A D D E N D U M

Project: EACS HS Classroom Renovations

Addendum No: 02

Date: 12-18-2024

Finishes Plan - Second Floor

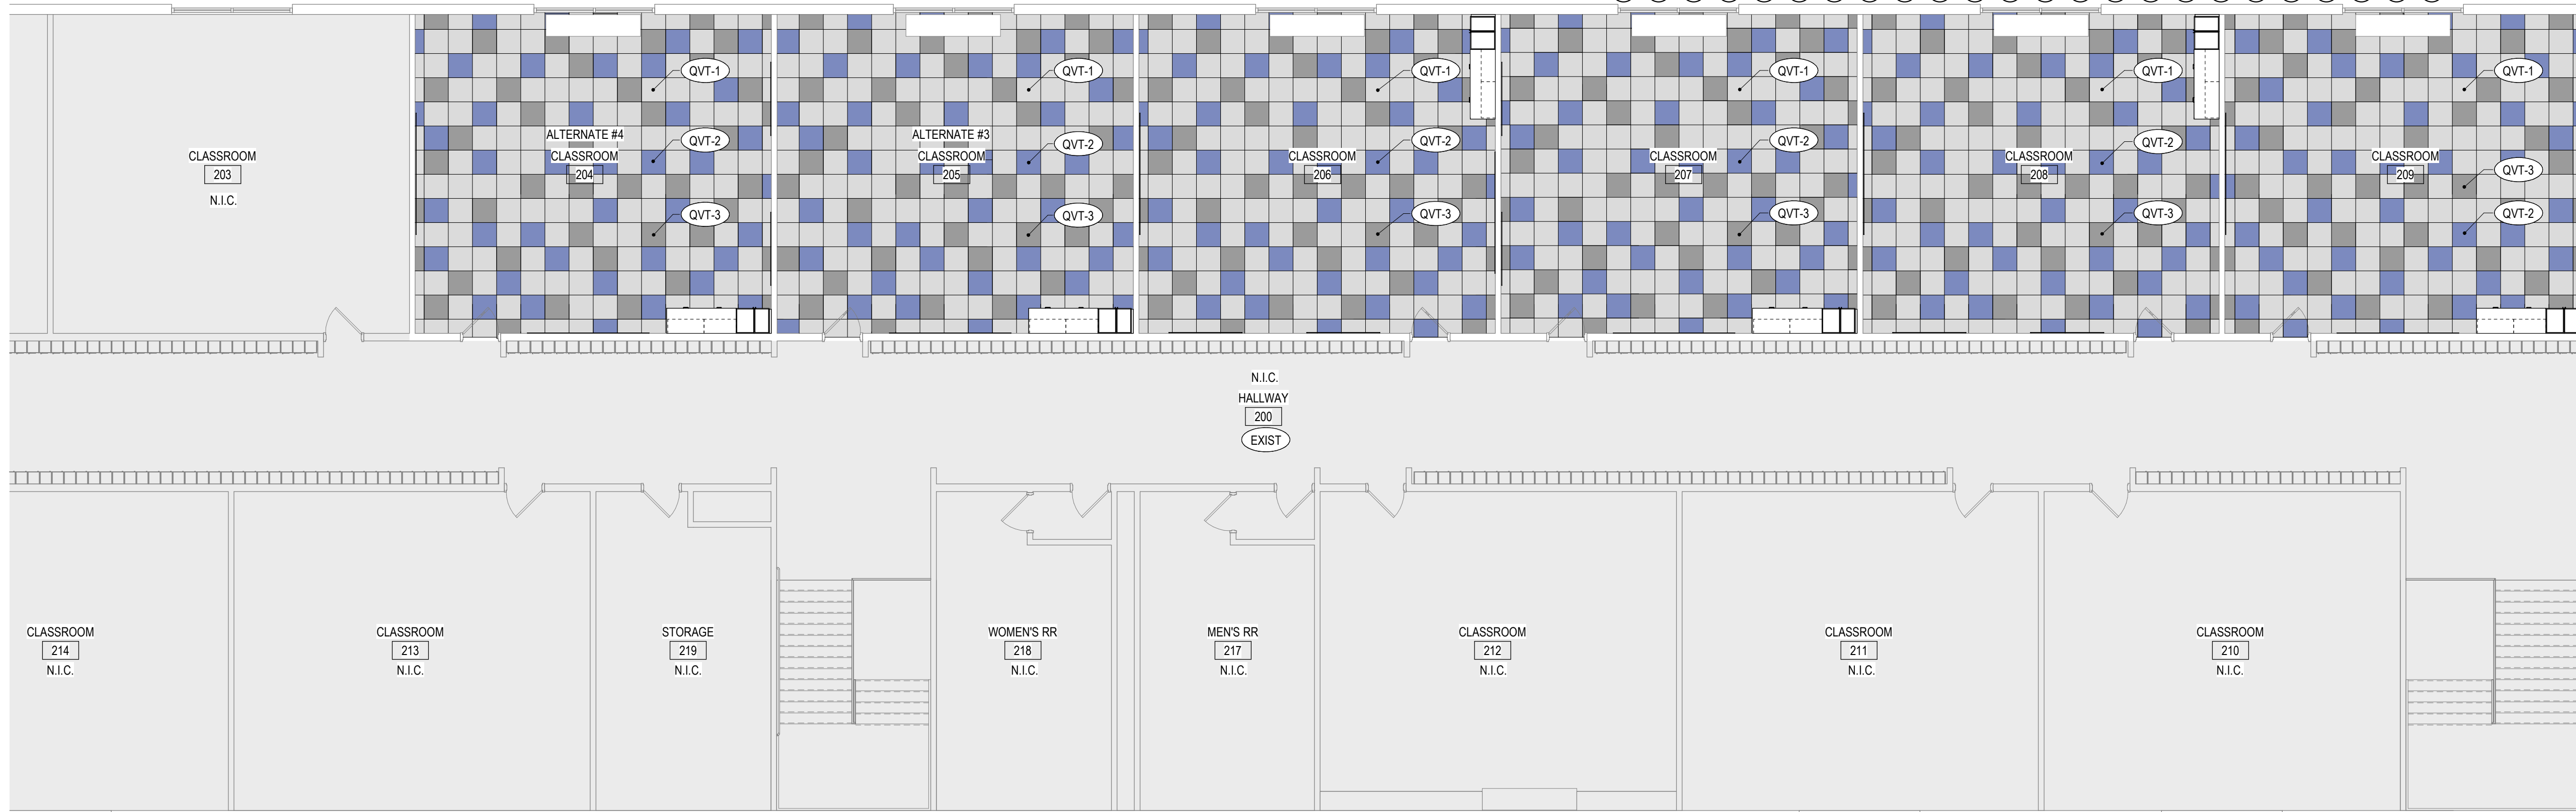
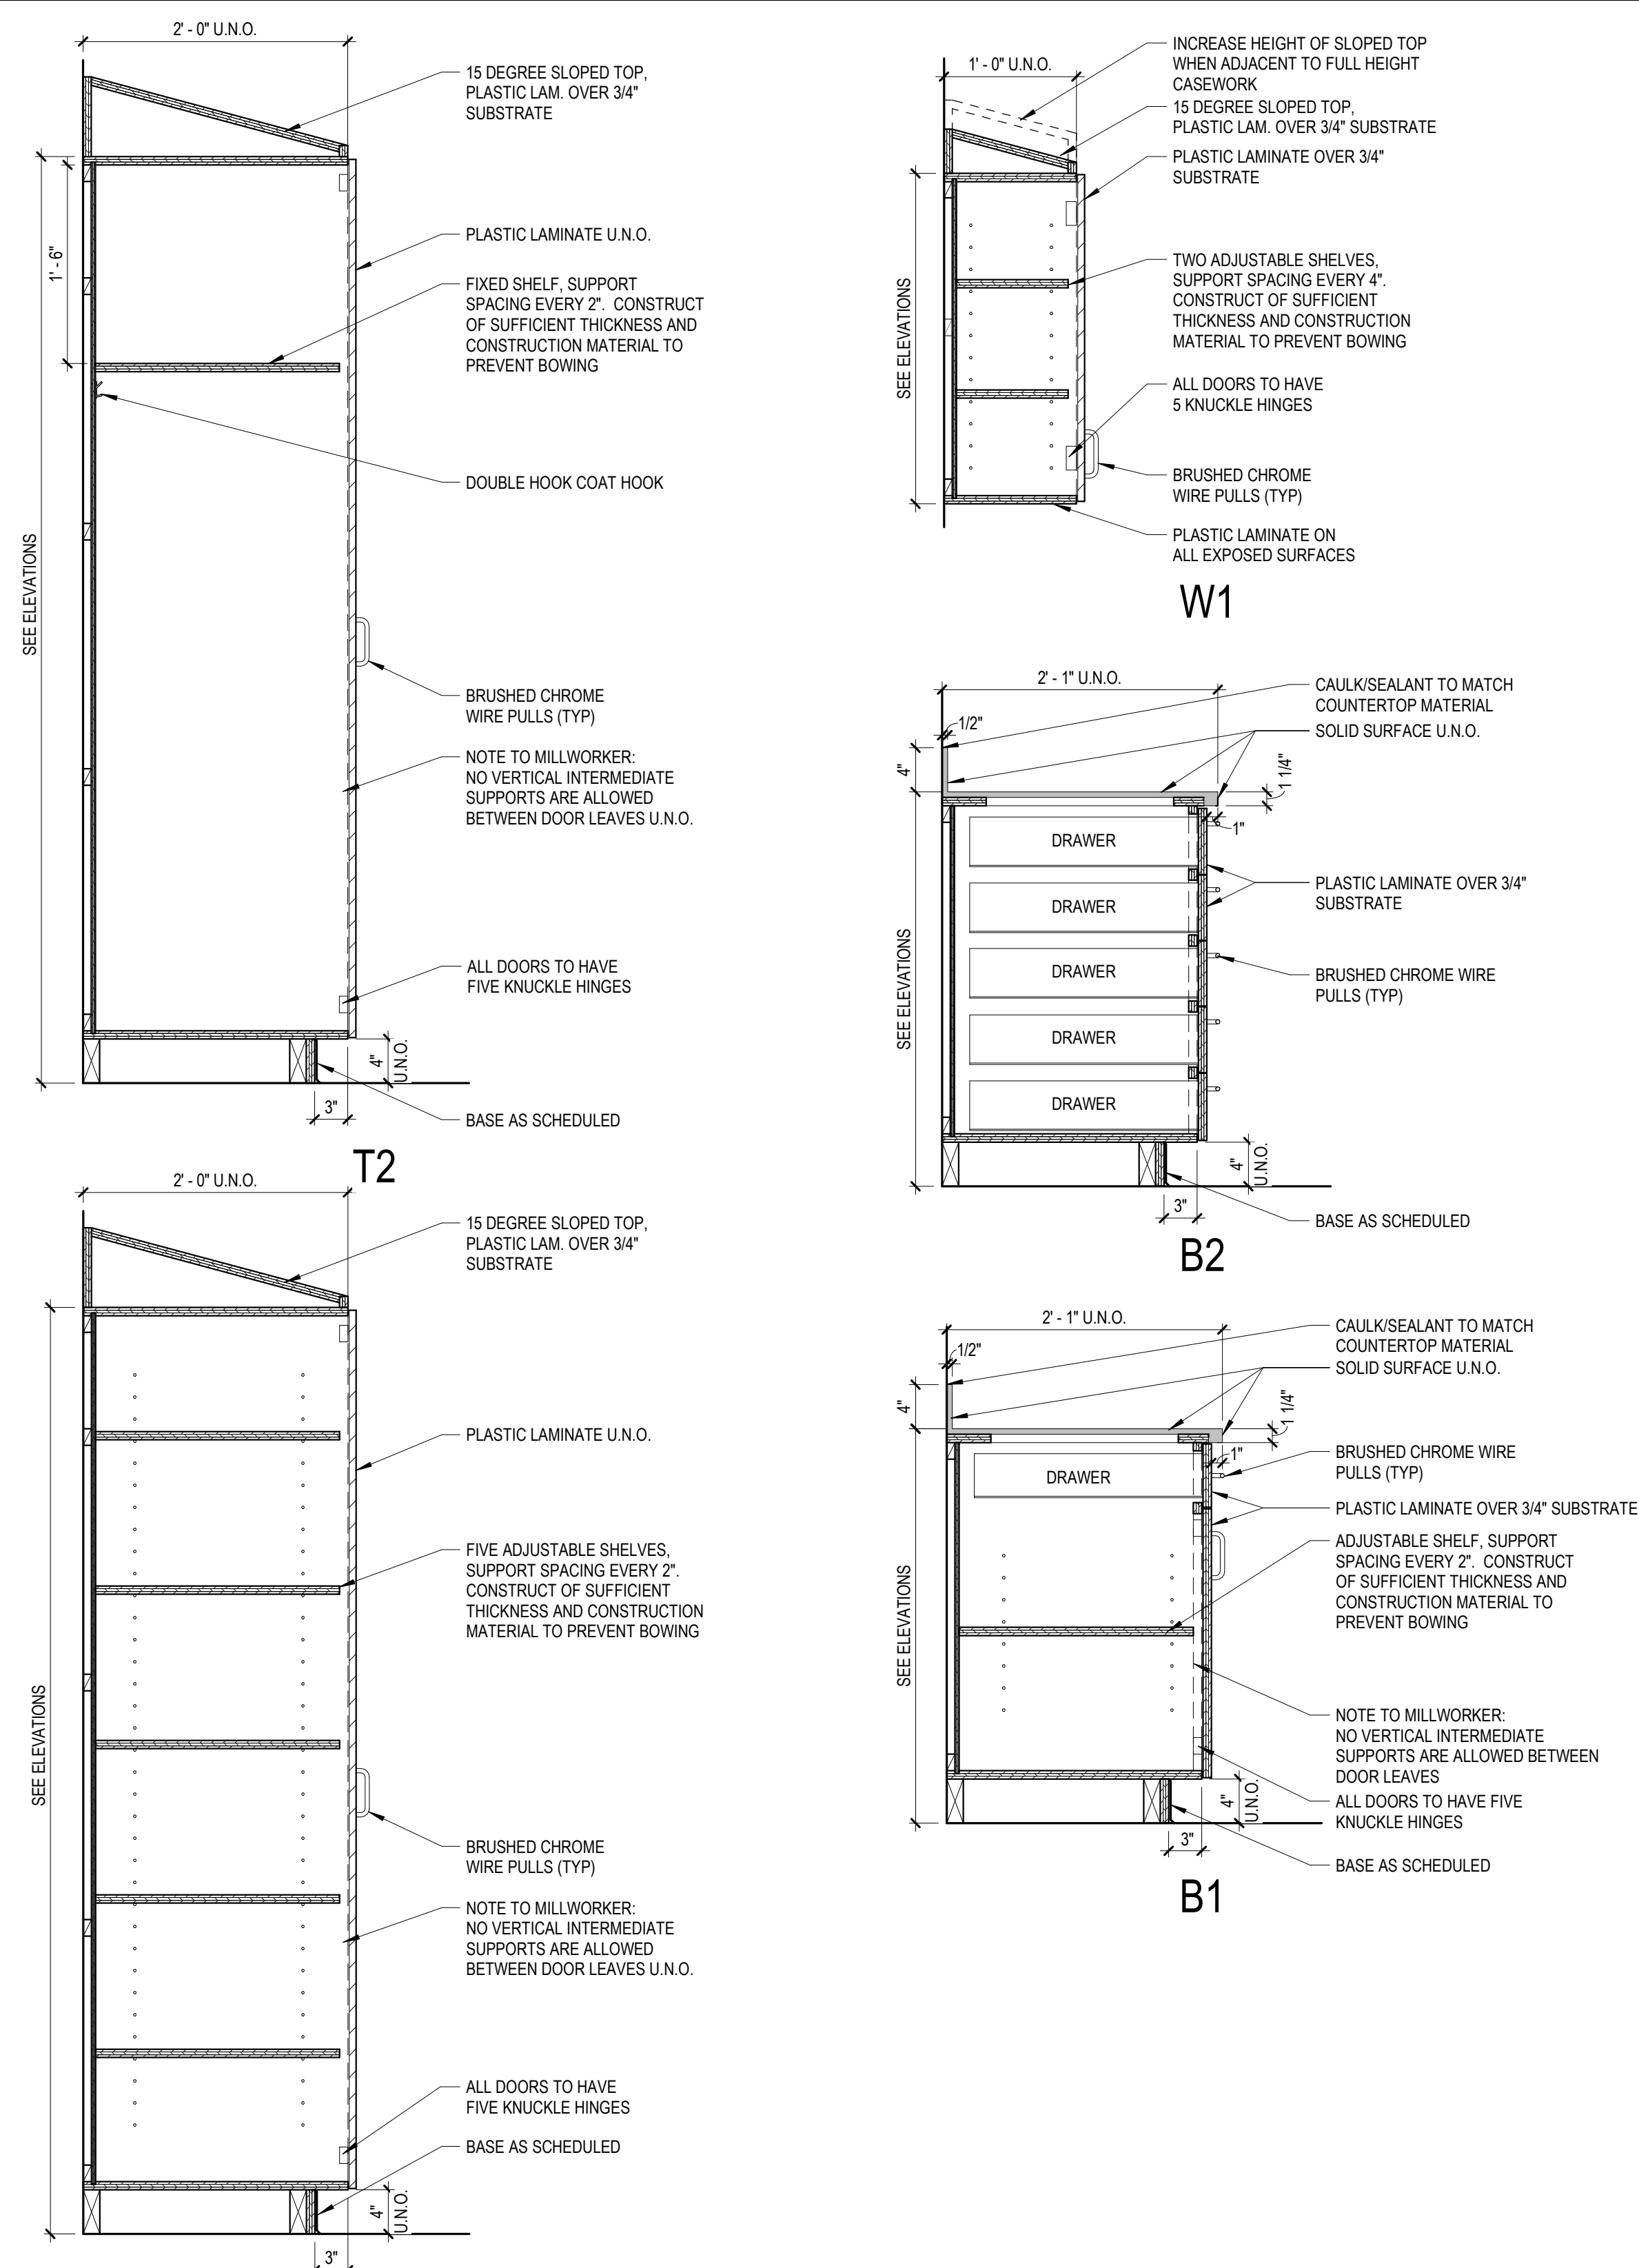
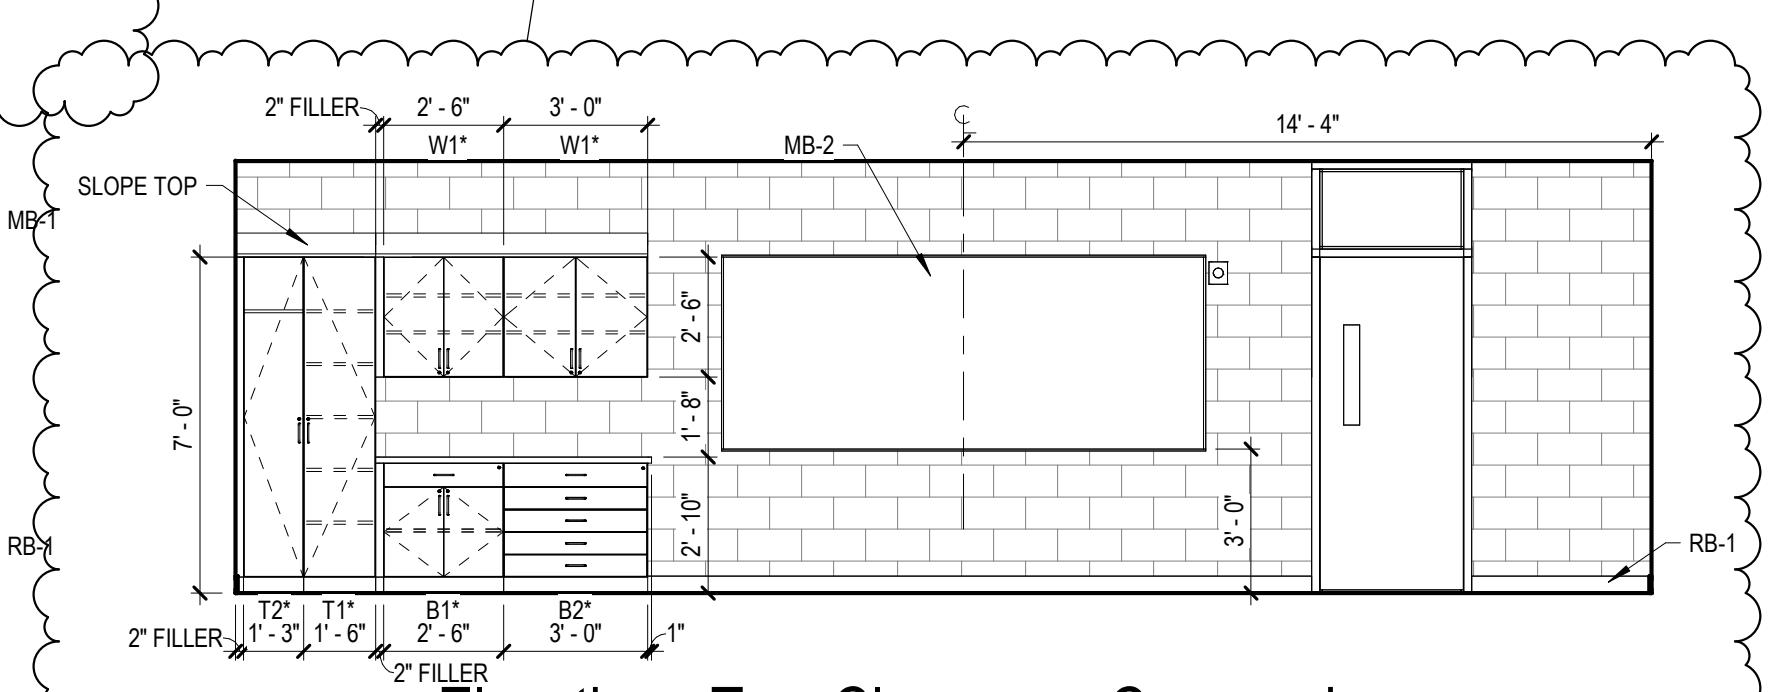
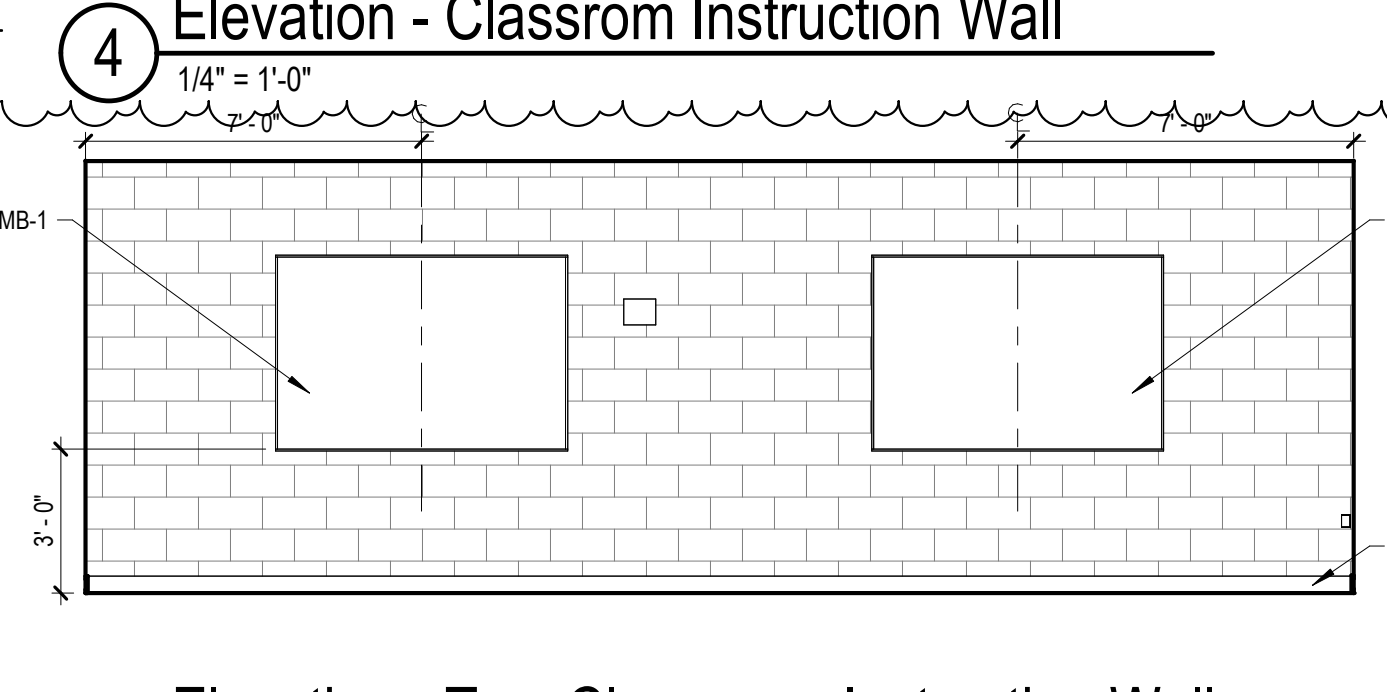
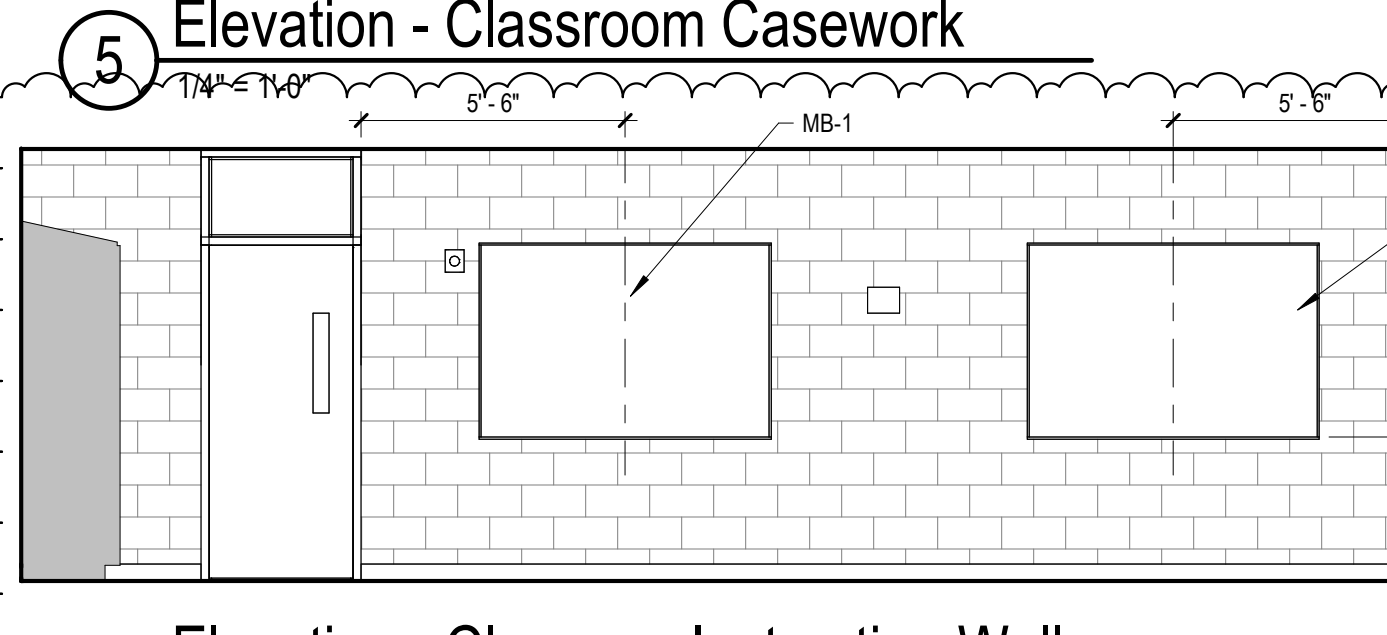
ITEM NO. 2.03 - DRAWING NO. A-141 Finishes Plan – Second Floor

- A. Revision to Elevation - Typ. Classroom Casework #2
- B. Revision to Elevation - Classroom Instruction Wall #4
